Midway City Council
4 May 2021
Regular Meeting

Saddle Creek Ranch,
Phases 2 & 3 /
Preliminary Approval

CITY COUNCIL MEETING STAFF REPORT

AGENDA ITEM: Phase 2 & 3 Preliminary

LANDSCAPE PLAN - PHASE 2-3

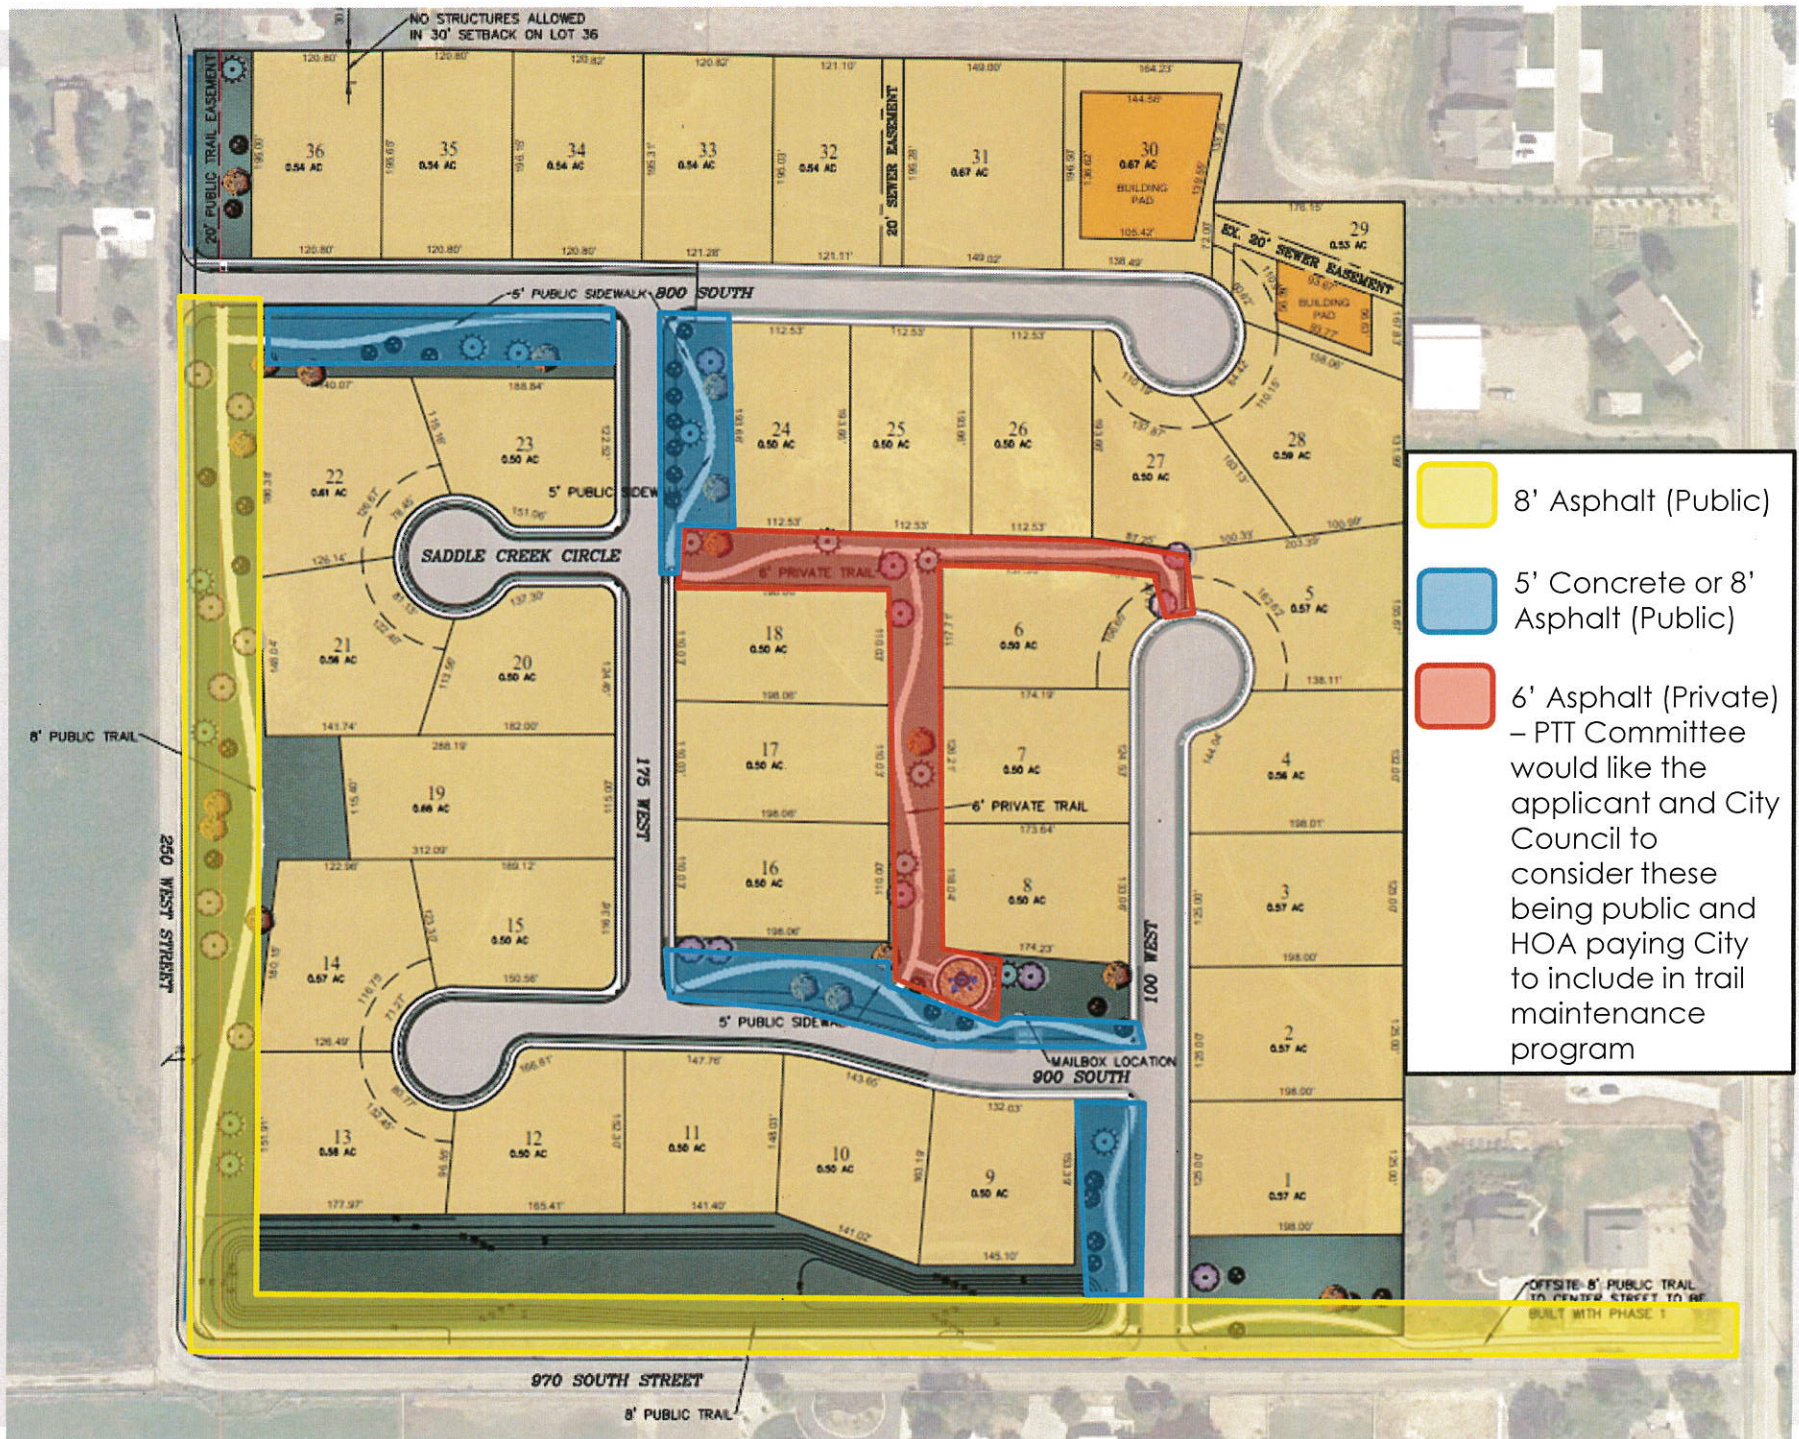
The Planning Commission requested that the Parks, Trails and Tree committee provide a recommendation to the City Council on whether sections of trail within the development, adjacent to roads and within open space, are 5' concrete as recommended by City staff or 8' asphalt as proposed by the applicant. Staff has recommended concrete primarily for maintenance purposes since the city will be maintaining them, the applicant would prefer asphalt because of the aesthetic and user experience.

Motion: Amanda Peterson: I make a motion that we recommend to the City Council that public paths within the development that are adjacent to roads and are within open space, are constructed as 8' asphalt trails. The reasoning is it will be safer, provide increased width and will enhance the continuity of trails within the open spaces.

Nays: Committee Members: Coleman – Agrees with the 8' asphalt trail but would like it to continue along 175 West in front of the proposed lots on east side of the street.

After the motion had passed, Committee Chair Bouwhuis requested that the City Council and developer consider the possibility of making all trails in the development publicly accessible (currently two sections of trail that are not adjacent to roads are anticipated to be private) and that the developer/HOA contribute annually to have the trails included in the City's trail maintenance program.

- 8' Asphalt (Public)
- 5' Concrete or 8' Asphalt (Public)
- 6' Asphalt (Private) – PTT Committee would like the applicant and City Council to consider these being public and HOA paying City to include in trail maintenance program
